# SERVICE BULLETIN NO. 179

## BlockerBeam

### 2001 Ford Superduty

### Ford F-250 / F-350/ F-450/ F-550 Trucks

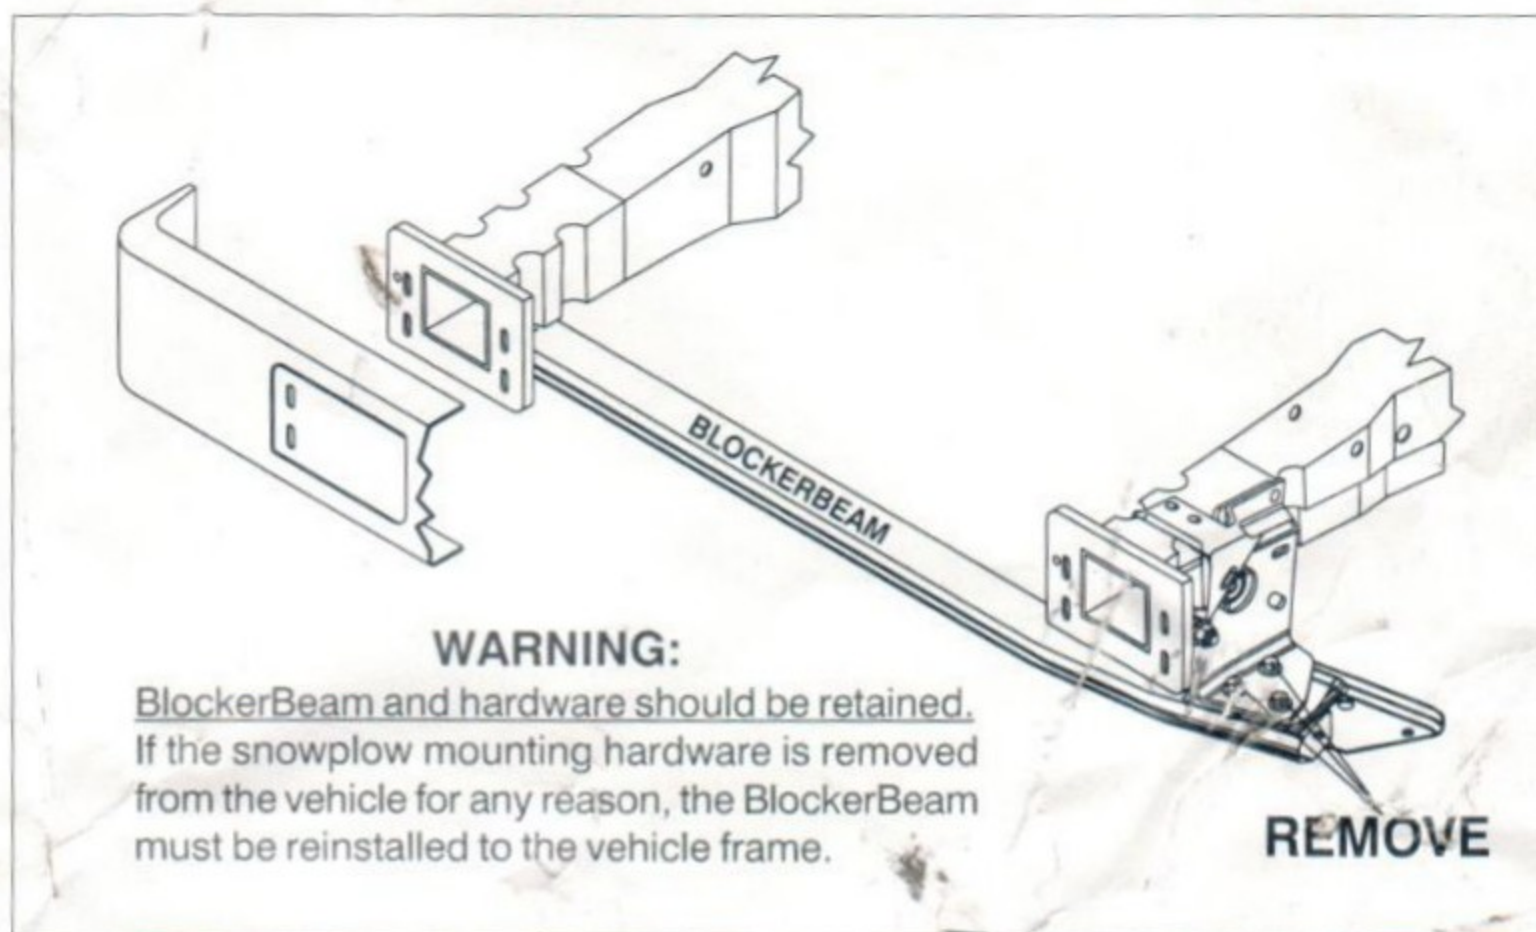
Reports from the field have indicated that Ford Motor Company has incorporated a metal cross member below the front bumper on the 2001 Model Year Super Duty Vehicles. This metal cross member is called a "**BlockerBeam**". The actual incorporation date is October, 2000.

To install a Meyer Snowplow onto these vehicles you must first remove the BlockerBeam. The BlockerBeam and hardware should be retained.

**Warning:** Removal of the BlockerBeam without the installation of the snowplow attachment hardware may effect air bag deployment in a crash. Do not operate the truck unless either the BlockerBeam or snowplow attachment hardware is installed on the vehicle.
